**Re: Incorrect Thermal broken Aluminum Joinery: 2 Rapare St. Job No.27363 - JSR Construction.**

Photo 1: Path of thermal conduction at the joint of window transom and sliding-door fixed interlocker and the same photo without marking is given side by side for easy reference

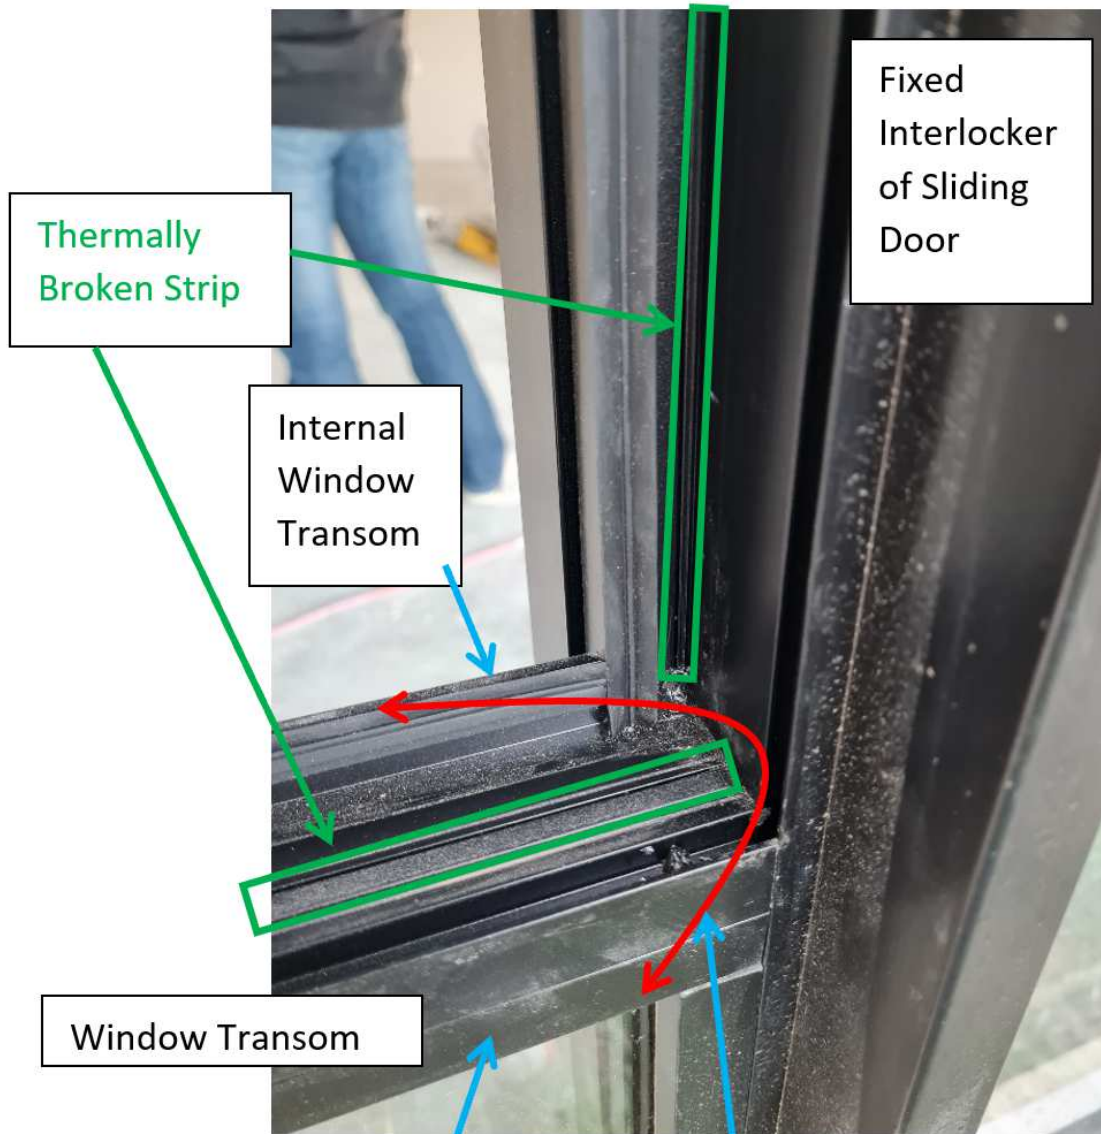
1. You shall replace all non-thermally broken components of the sliding doors and windows which including but not limited to the stiles and fixed interlocker. There is a path of thermal conduction where it is not thermally broken at the joint of the window transom and sliding-door fixed interlocker as indicated by the red line on the marked photo as shown on Photo 1 below. The same photo without marking is given side by side for easy reference. You are required to change the fixed interlocker to have the proper thermally broken strip align with the strip on the window transom. I also took a thermal image (see Photo 2) with the sunshine reaching half the height of the sliding door. It showed that the non-thermally broken components (the joint in between the interlocker and the window transom, and the stiles) creating a thermal conduction between the internal and external parts of the thermally-broken members (e.g. bottom of the sliding door frames and the window transom).

Path of thermal conduction (red line) between internal and external parts of the window

Photo 1 – Indicating the non-thermally broken parts of the Sliding Door “Lounge D6” (Door number referred to the attached quote no. 27363) (Trim Size: 2130 x 2700; Area: 5.751 m sq.)

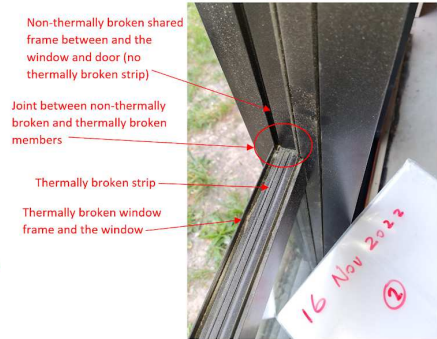
- a) Photo 1 – Indicating the non-thermally broken parts of the Sliding Door “Lounge D6” (Door number referred to the attached quote no. 27363) (Trim Size: 2130 x 2700; Area: 5.751 m sq.)

Figure 1 - Photo location plan

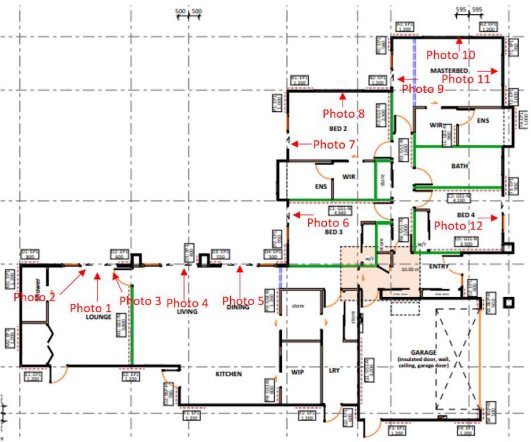
- 1) The parts of the windows and doors frames do not have the thermally broken strip. These windows and doors make up 59% of the area of all the aluminium joinery products. The total area of these problematic aluminium joinery is 28.8 m sq. The total area of all aluminium joinery products is 48.6 m sq. These problematic products are shown in the following photos (note that the photos and the location plan are given at the end of this email):
